# Clearwater Specific Plan Environmental Impact Report

# FINAL ENVIRONMENTAL IMPACT REPORT THE CLEARWATER SPECIFIC PLAN

SCH NO. 2006062154

Subject: Response to Comments: Mammoth Clearwater Revised Site Plan

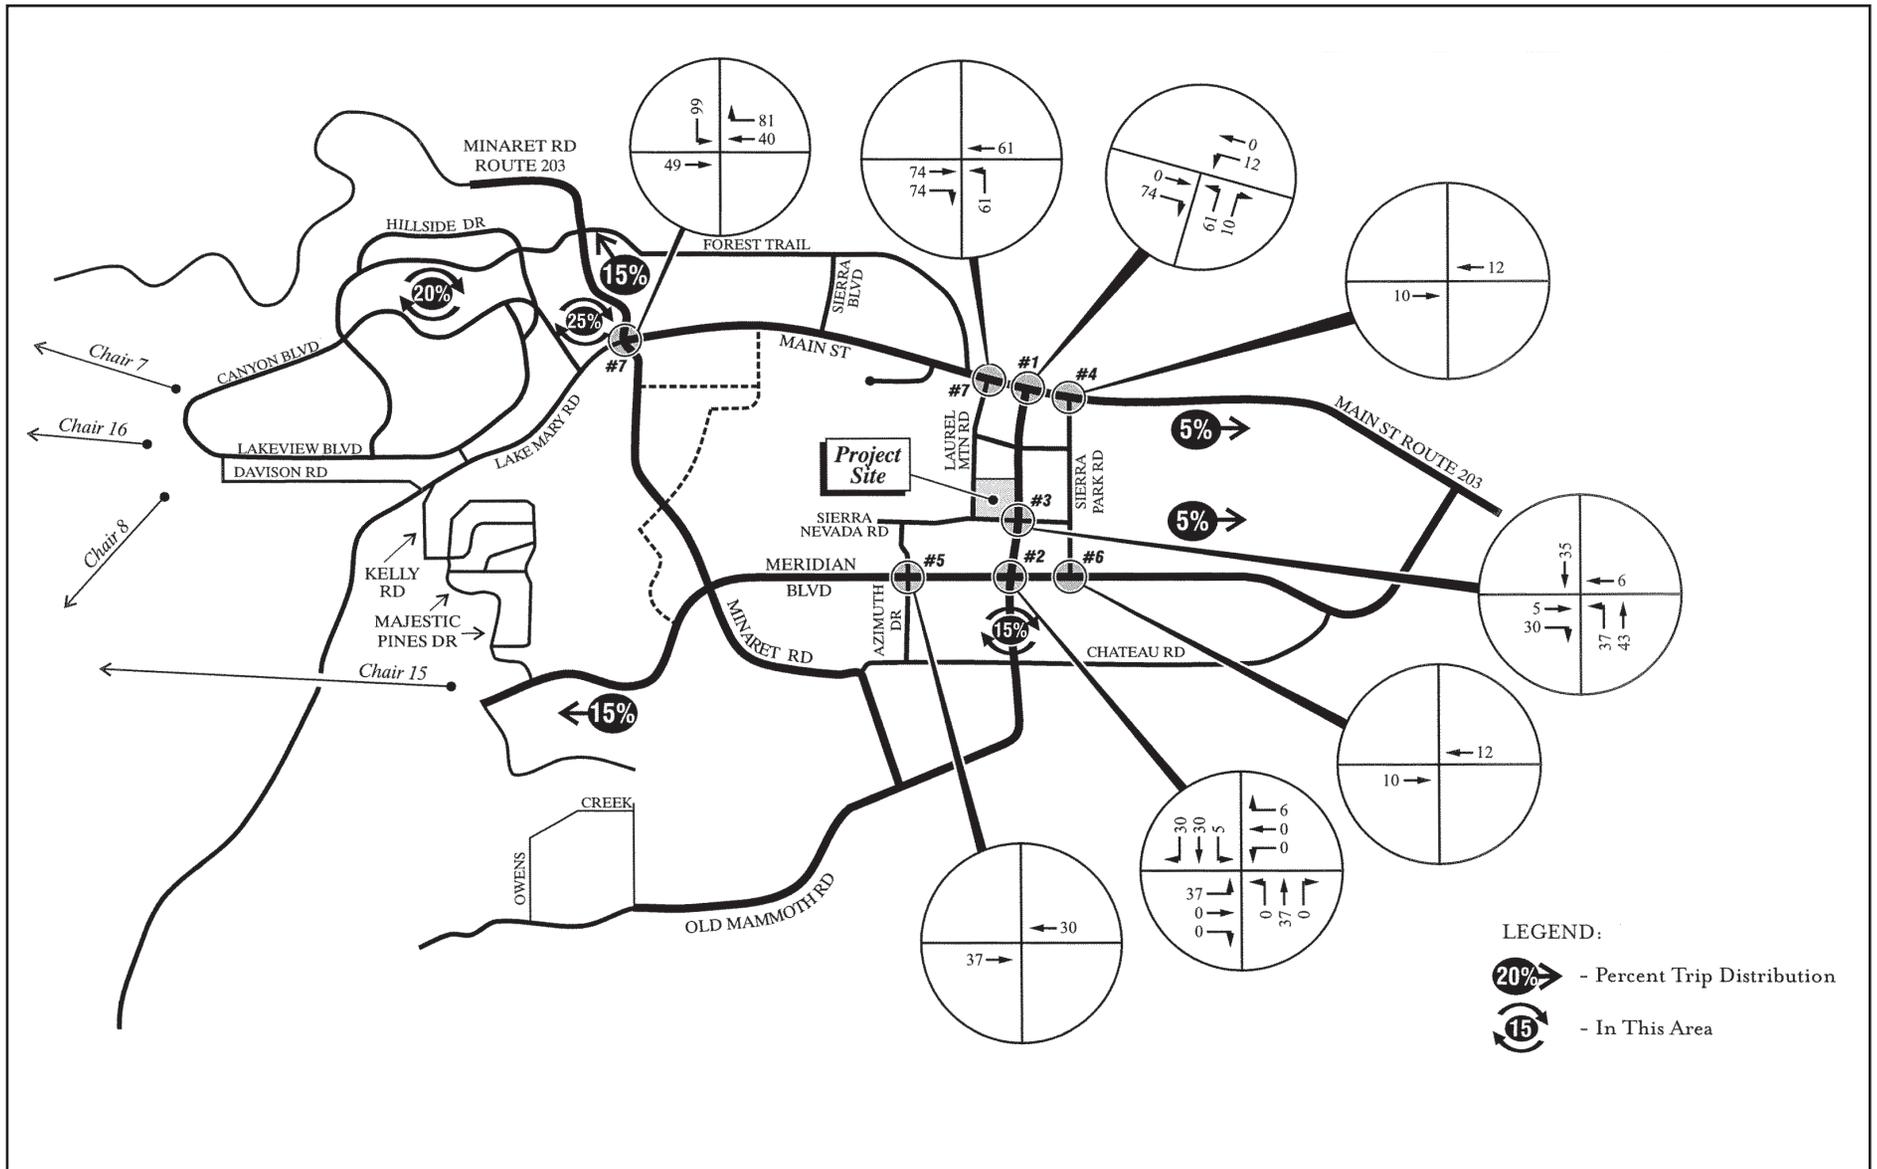
Please refer to the revised Exhibit 5.3-5, *Cumulative Projects Trip Generation*, for a clarification on the location of the cumulative projects.
